1st Further Information

**Proposed Temporary Place of Recreation, Sports or Culture (Hobby Farm) with Ancillary Eating Place and Associated Filling of Land for a Period of 5 Years in "Agriculture" ("AGR") Zone and Area shown as 'Road',
Various Lots in D.D. 17 and Adjoining Government Land, Ting Kok, Tai Po, New Territories**

(S.16 Planning Application No. A/NE-TK/843)

Response-to-Comment (RtC)

Annex 5 – Site photos showing the existing drainage facilities implemented by the applicant

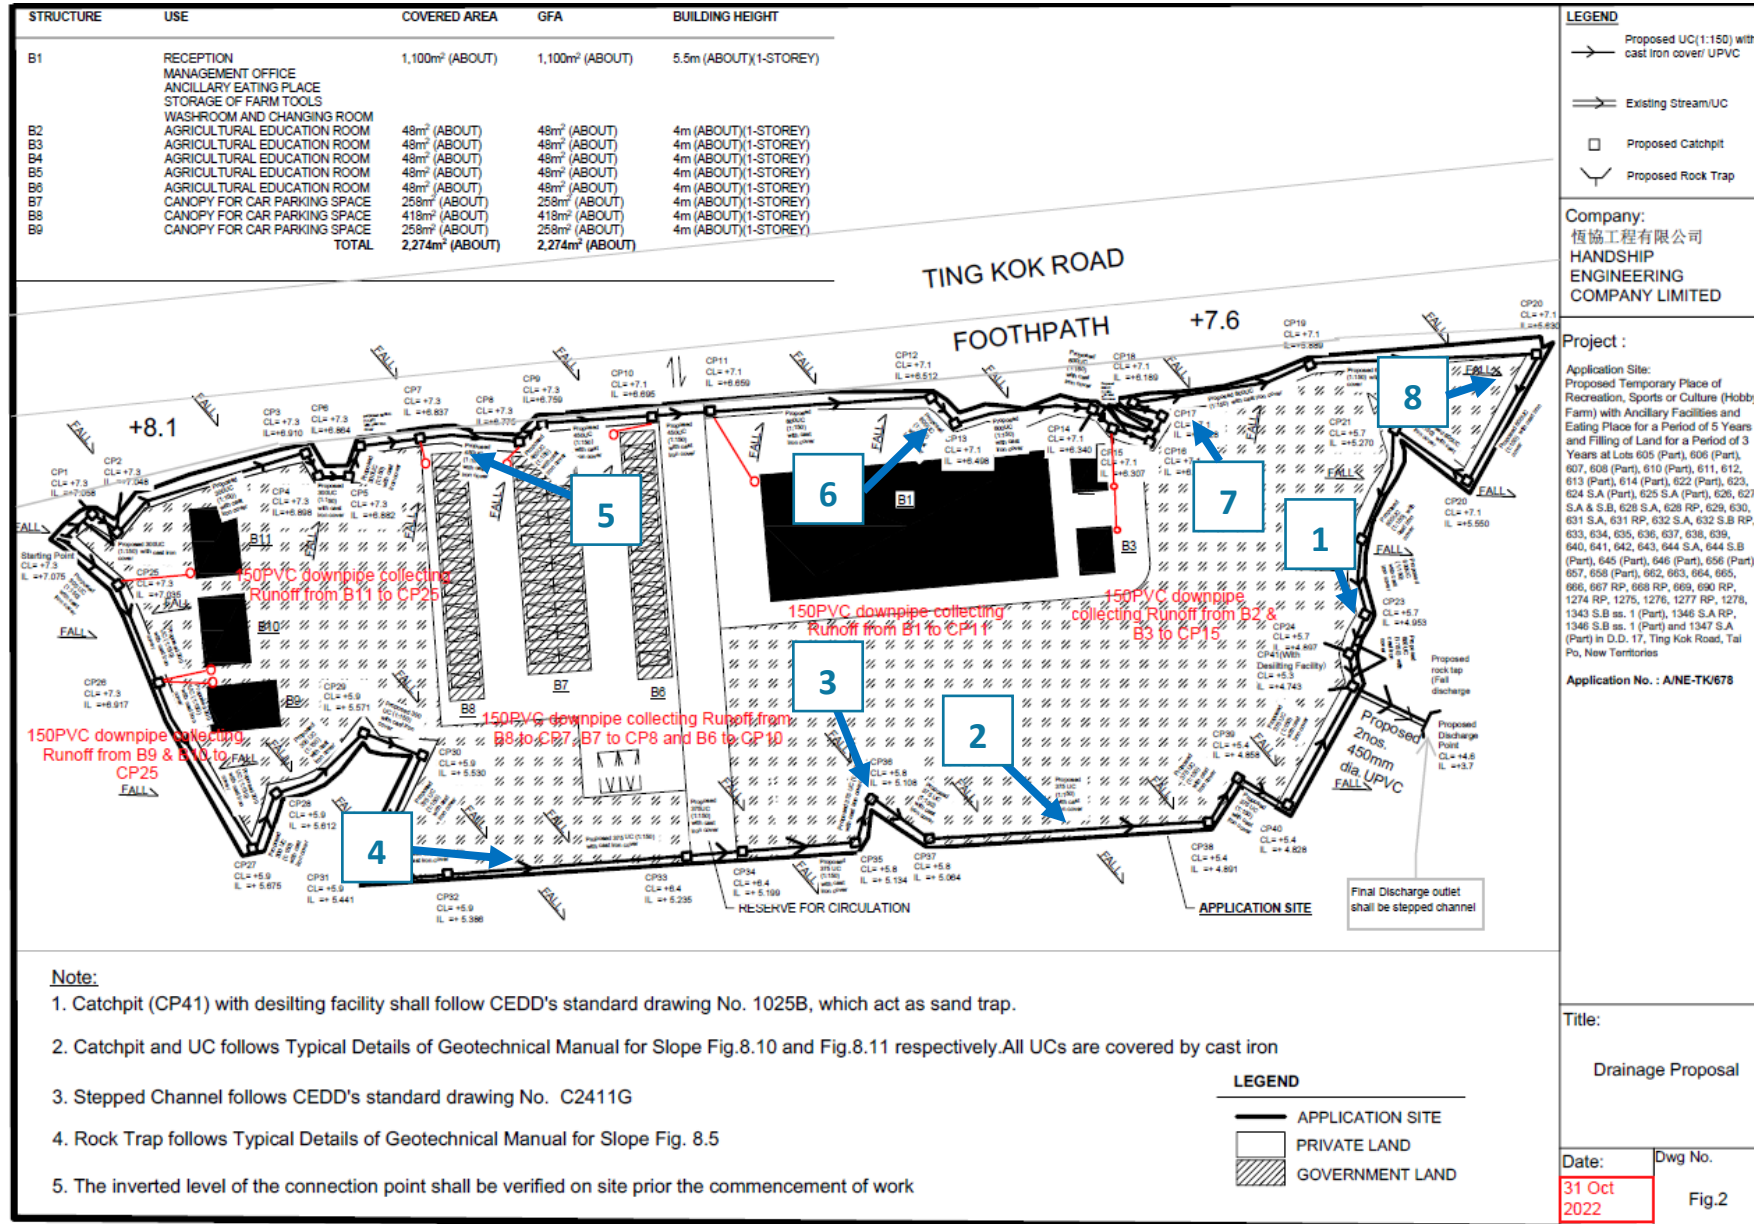
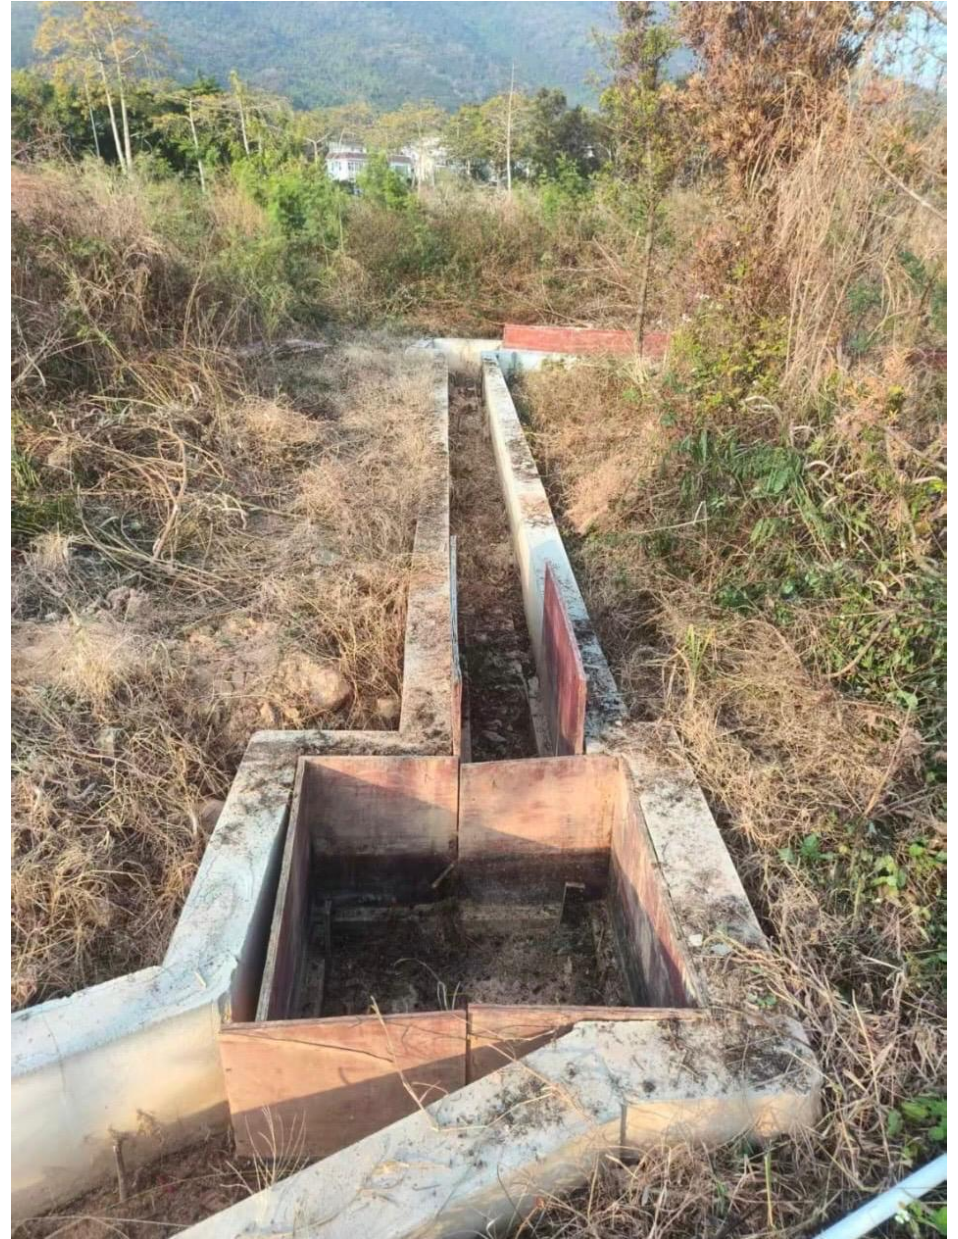
- (ii) In response to the comments from the Chief Engineer/Mainland North, Drainage Services Department (CE/MN, DSD), the applicant provides photographic records of the completed drainage facilities at the Site. Please refer to **Annex 5** for details. Notwithstanding that the drainage proposal was accepted by CE/MN, DSD on 07.12.2022 under the previous application No. A/NE-TK/678, the applicant had launched the implementation works of the drainage facilities at the Site. However, the applicant was not able to finish the implementation works before the revocation the previous application. Therefore, the remaining part of the implementation works has been paused since then. Upon obtaining relevant planning permission from the Town Planning Board (the Board), the applicant will continue to complete the accepted drainage proposal and submit full set of photographic records for the consideration by the Drainage Authority.

DWG. TITLE
LAYOUT PLAN

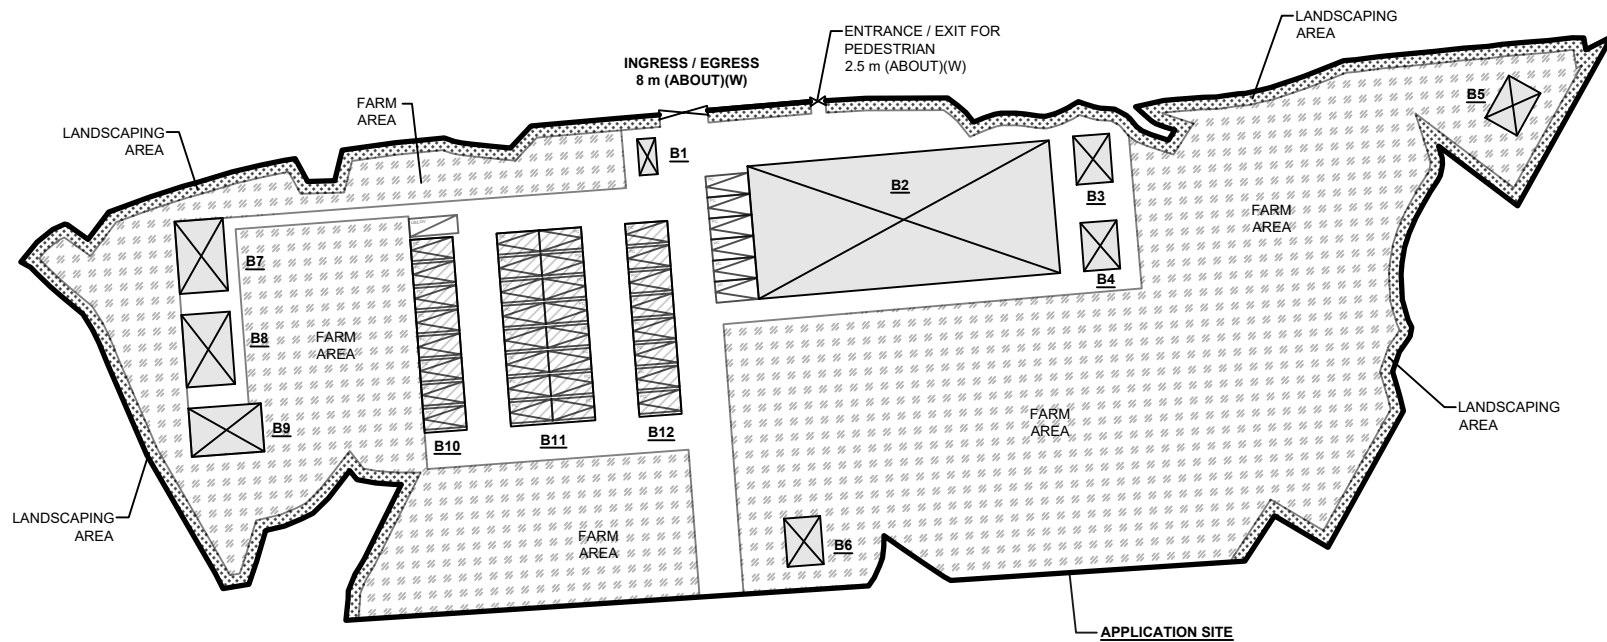
Departmental Comments	Applicant's Responses
10. Comments of the Commissioner for Transport (C for T)	
<p>(a) We note that the site is the subject of the previous planning application No. A/NE-TK/678 which was submitted by the same applicant of this subject planning application. The site layout of the subject application No. A/NE-TK/678 proposed to provide 38 private car parking spaces and 2 LGV loading and unloading spaces with 140 visitors on weekends. However, this application proposes to provide 32 private car parking spaces, 1 light bus parking space and 1 LGV loading and unloading space serving maximum number of 150 visitors on Saturdays, Sunday and public holidays. The application shall justify the sufficiency on the provision of parking spaces and loading and unloading spaces.</p>	<p>Upon further review, 38 private car (PC) parking spaces, and 1 loading and unloading (L/UL) space shared by light goods vehicle (LGV) and light bus (LB) are proposed, which are consistent with the previous approved planning application No. A/NE-TK/678. The revised layout plan is enclosed at Appendix A of Annex 3.</p> <p>LGV will be deployed for the transportation of goods during non-peak hours on weekdays, and the provision of L/UL space is based on user requirement, which is considered to be sufficient.</p> <p>Moreover, visitors accessing by PCs will be strictly required to make prior appointment, which would serve to regulate the number of vehicles accessing the Site. No walk-in visitor will be accepted. The maximum occupancy of the car park would not exceed 38 PCs and 1 LGV/LB. By adopting an average occupancy rate of 3.5 persons/PC and 24 persons/LB, the parking provision can meet the demand for about 157 visitors. Given the maximum nos. of visitors on Saturdays, Sunday and public holidays is expected to be 150 persons, the provision of parking spaces is therefore considered to be sufficient.</p>

- (iii) The applicant provides the following revised documents at **Annex 6** to reflect the changes in the provision of parking and L/UL provision as mentioned in Part 10(a) of the above RtC table:
